780 Keypad Feature Update July 2007

Version 101 Firmware Update

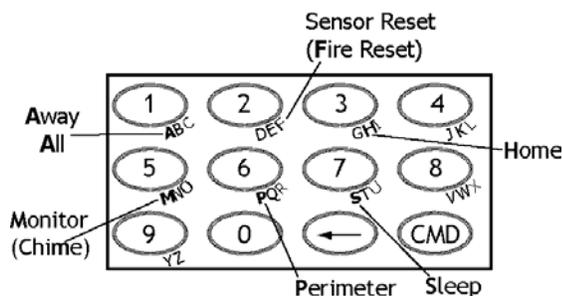
When using an All/Perimeter or Home/Sleep/Away arming system, the 780 now demonstrates Cancel/Verify operation. This replaces the previous DISARM/SILENCE operation.

While armed, pressing the far left top row Select key simulates a front door zone fault and starts the entry delay.

After 10 seconds, the keypad displays FRONT ENTRY DOOR alarm. Entering any 4-digit code displays CANCEL VERIFY. Press the Select key under CANCEL to turn off the Red keypad backlighting and silence the alarm. ALARM CANCELED is displayed. Press the Select key under VERIFY to silence the alarm only. ALARM VERIFIED is displayed.
